Land Adjacent to Sturt Avenue, Haslemere

Flood Risk Assessment and Drainage Strategy

Date: December 2023
Project No. 303383
Revision: 07

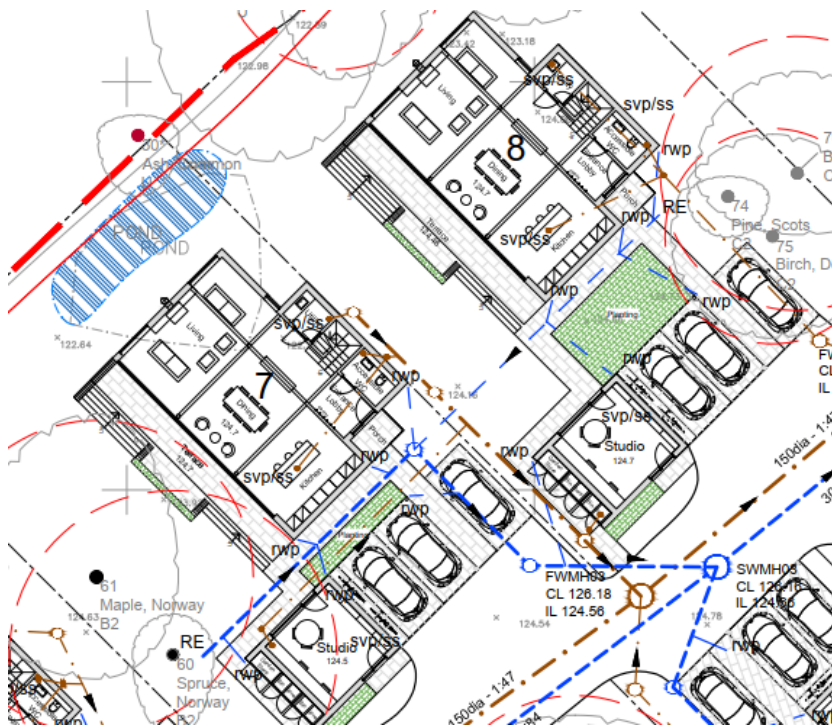
5.2.10 The EA commented that due to potential wet and waterlogged areas noted on site that the proposed finished floor levels of the properties should be raised to avoid any potential flooding of properties.

We would confirm that this has been incorporated where required into the design as already submitted.

The extract above shows properties on the north western side of the proposed development with steps up to the ground floor level from the higher side of the plot, indicating that the ground floor is protected from any potential water. Along the north western boundary This level difference is approximately a minimum of 450mm above existing ground levels. Along the south eastern boundary, the properties are a minimum of 150mm above proposed external levels. FFL's can be seen on the Drainage Strategy drawing in Appendix H.

Appendix I
Proposed Bridge Detail

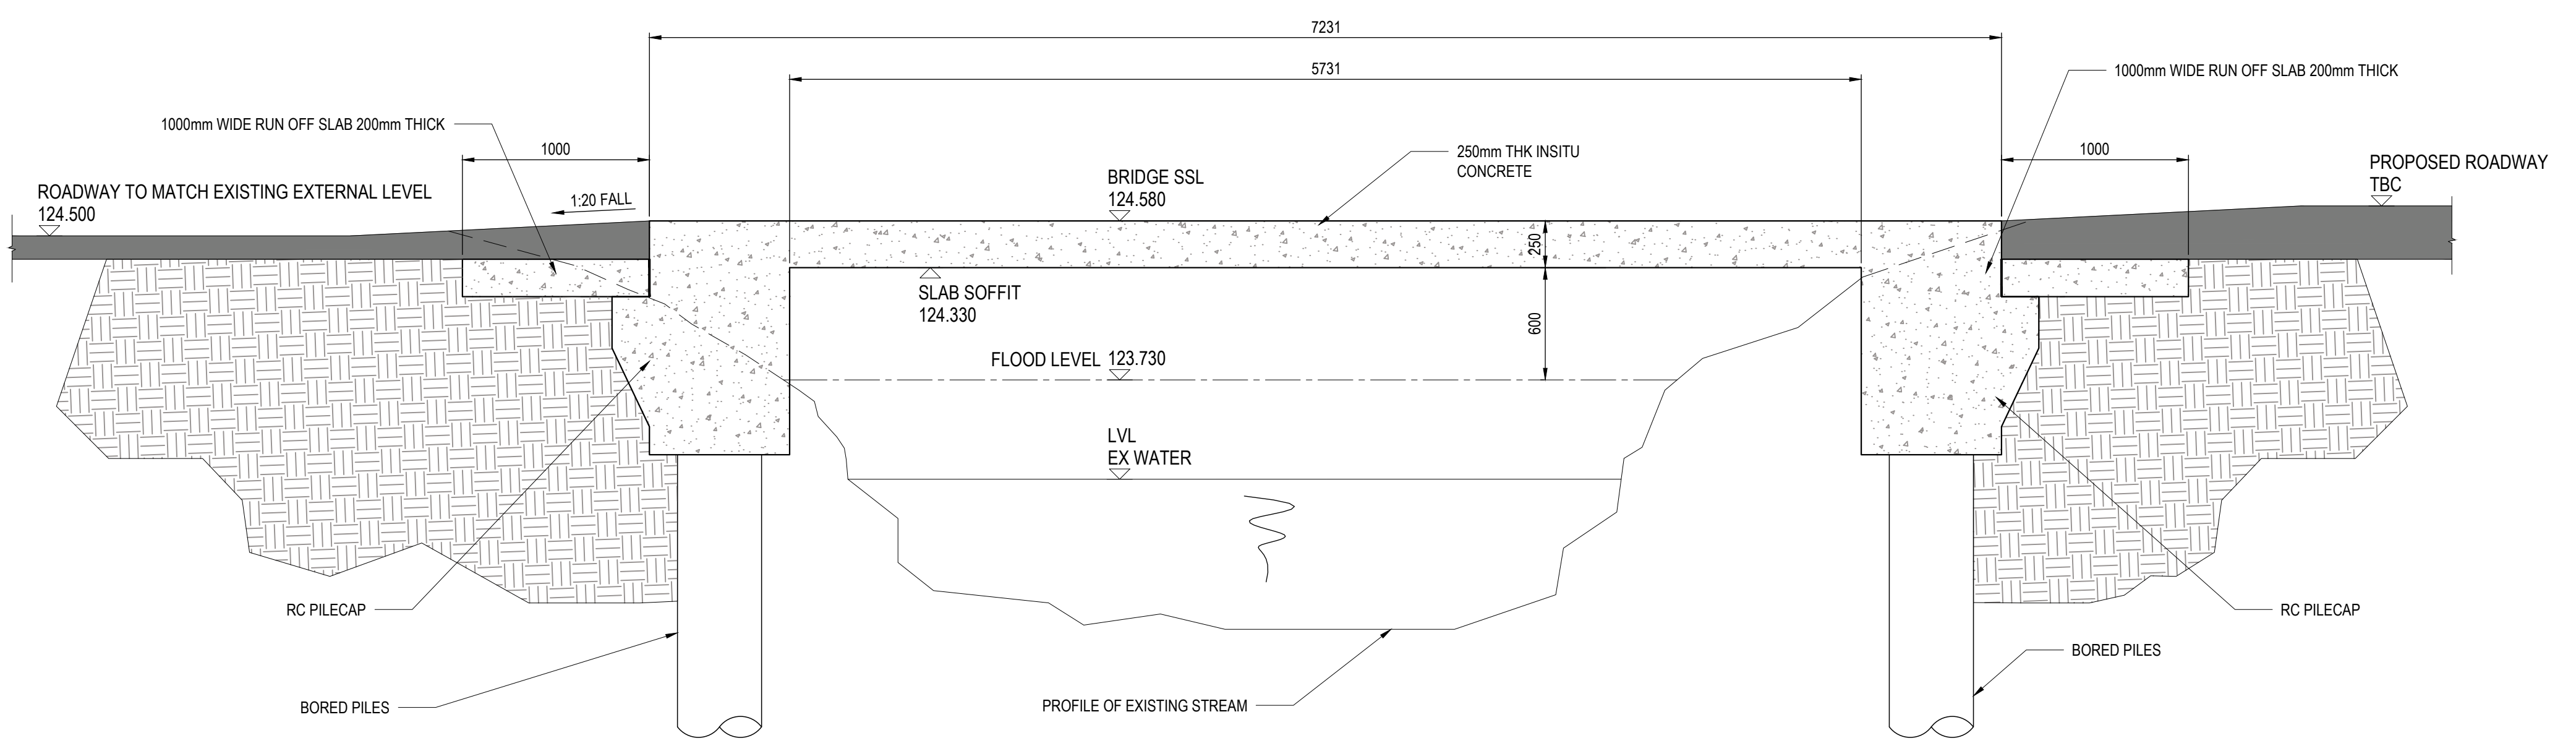
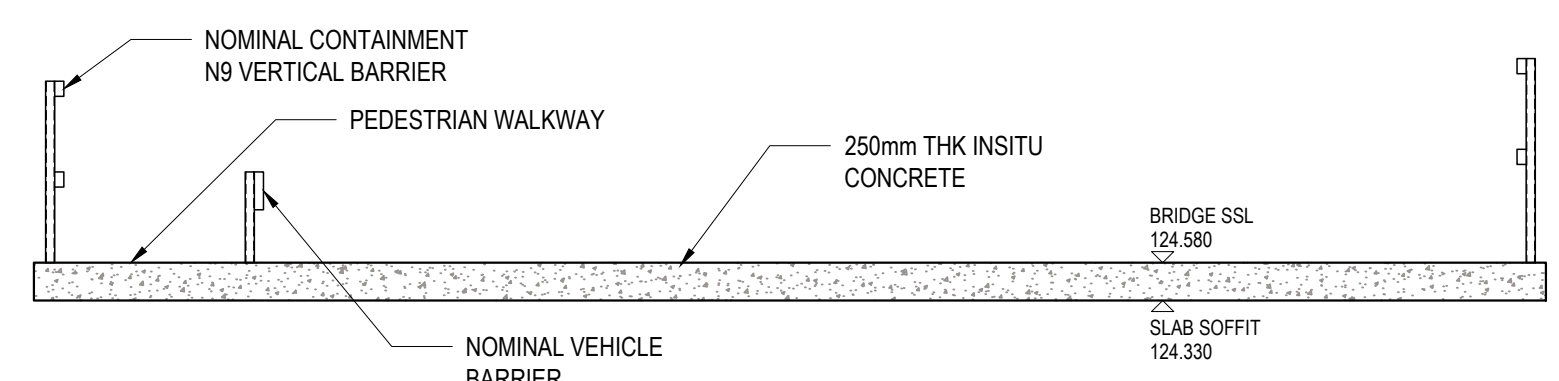
The proposed bridge is mentioned briefly in the planning statement and FRA and the location is shown on the site layout drawing. There were no design drawings or details in general submitted. We note that this is a Full Application. This bridge would be the only point of access to the site. We would require drawings/plans to be submitted for the proposed bridge. The FRA would also need to assess the proposed bridge from a flood risk perspective and in the assessment it needs to consider the latest climate change allowances. In the FRA it must demonstrate that the bridge is not affecting the surrounding area and properties as well as the river and its flow.

Appendix B Crouch Waterfall Bridge Drawing – 16-178G 001 P01.2 shows that 600mm freeboard will be applied to 123.73m AOD (70%) flood level in order to allow floating debris to pass freely through the structure. The proposed soffit is 124.33mAOD. We advise that a 600mm freeboard be applied to new bridges and that the soffit should be no lower than 300mm above either of upstream bank tops. As this second part will not be met, we would wish to see that the highest assessed allowance of 70% is applied with the 600mm freeboard for the bridge soffit, which we can see the applicant is proposing.

The applicant has now included the proposed access bridge general arrangement drawing (drawing no: 001 Rev.P01.3 (Appendix I)) which provides information of the proposed bridge which is also referenced in section 5.2.7 of the FRA. The soffit level of the bridge is 124.33m AOD, with a freeboard of 600mm above the 123.73m AOD (1 in 100 plus 70% CCA) which we welcome. The FRA confirms the existing footbridge will be removed.

We requested that the abutments be moved back to avoid encroachment. The applicant previously stated that the southern abutment could be moved back. The proposed access bridge general arrangement drawing (Drawing number 001 Rev.P01.3 (Appendix I)) confirms this. We mentioned that consideration should be made to potential scour and the design should consider measures to reduce or prevent potential scour to abutments or bank. Where bank protection is required, soft engineered approaches should be considered where possible. There is reference to bank protection being provided on the proposed access bridge general arrangement drawing but no specifics. The FRA (section 5.2.7) states "bank protection will be provided where deemed necessary to prevent scour, and this will be assessed at detailed design stage".

The requirement from the EA was to provide a freeboard of 600mm from the bridge soffit. Initial designs could not achieve this, but since the meeting the project team have reviewed the design requirements and can show that 600mm freeboard can be achieved even with the 1:100 + 70%.

Please refer to Appendix B for revised bridge proposal drawings.

Appendix J
Long Section Drawing

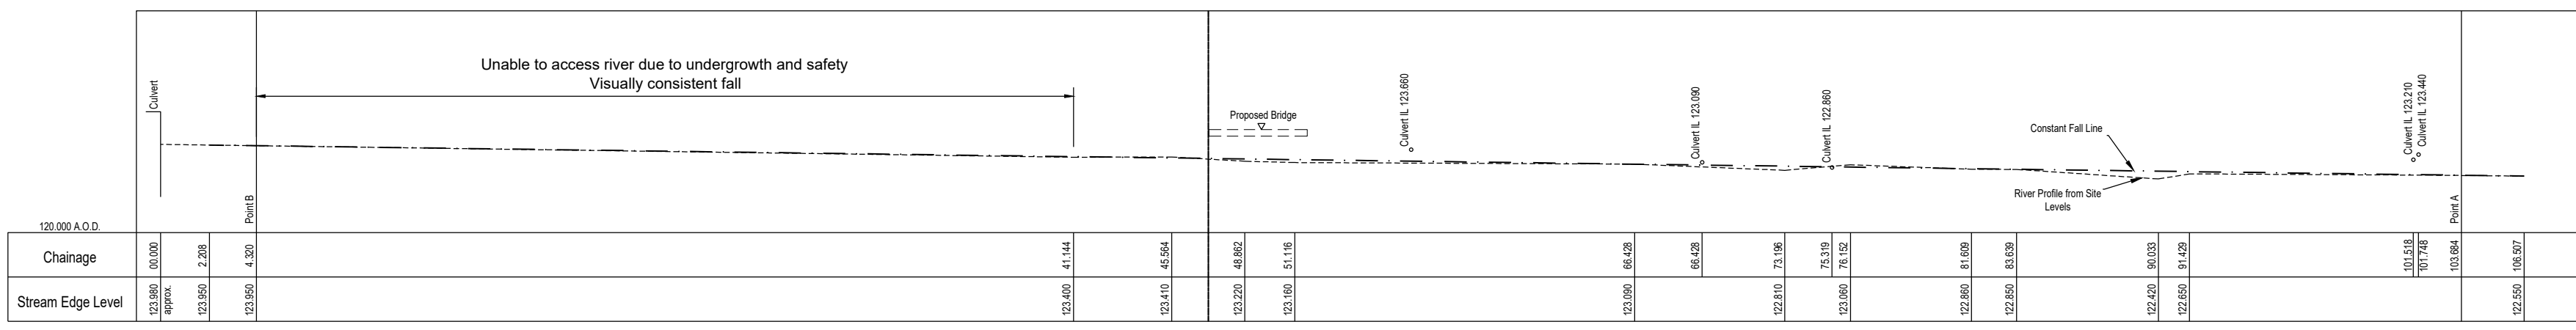
We are pleased to see that this FRA has been updated to explain how the flood level was calculated by way of interpolation and by supplying the survey (reference: SWH Long Section Drawing - 303383-SWH-XX-XX-DR-C-505-P01 dated 08.12.2021) to show there is a relatively consistent fall in levels.

As a result, a long section has been developed for the full length of the river from the culvert to below Point A. Please see Appendix A, drawing 303383-SWH-XX-XX-DR-C-505-P01 which shows details of the long section and bridge position.
